Washington State On-Site Wastewater Technical Review Committee

Minutes for the February 6-7, 2002 Meeting

Approved on April 17, 2002 by Vote of the Committee

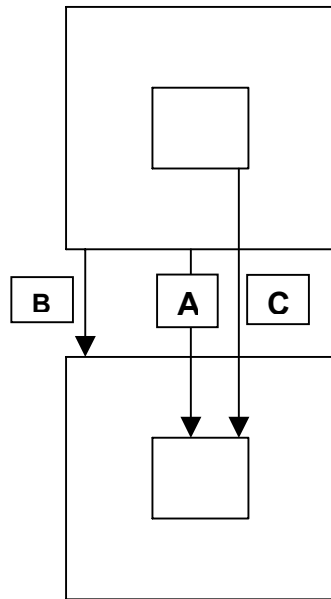
- Questions were asked about where the measurements should be from when there are downslope Glendon Biofilter units. He suggested that the setbacks should be measured from basin edge to basin edge (noted as distance C in the figure on the next page).

- **Motion:** Scott Jones – On a sloped site ($>5\%$) the horizontal setback between two Glendon units be measured from the downslope toe of the upper unit to the upslope basin edge of the downslope unit (noted as A in the figure on the next page)

- **Motion:** Kevin Barry – On flat sites ($\leq 5\%$), stacking of Glendon units should be “stacked” in one horizontal dimension only. If the stacking of units in 2 horizontal dimensions is proposed, then the setback should be measured from the downslope toe of the upslope unit to the upslope toe of the downslope unit (dimension **B** in figure below).
 - **Second:** Scott Jones
 - **Vote:** Yes – 9 No – 0
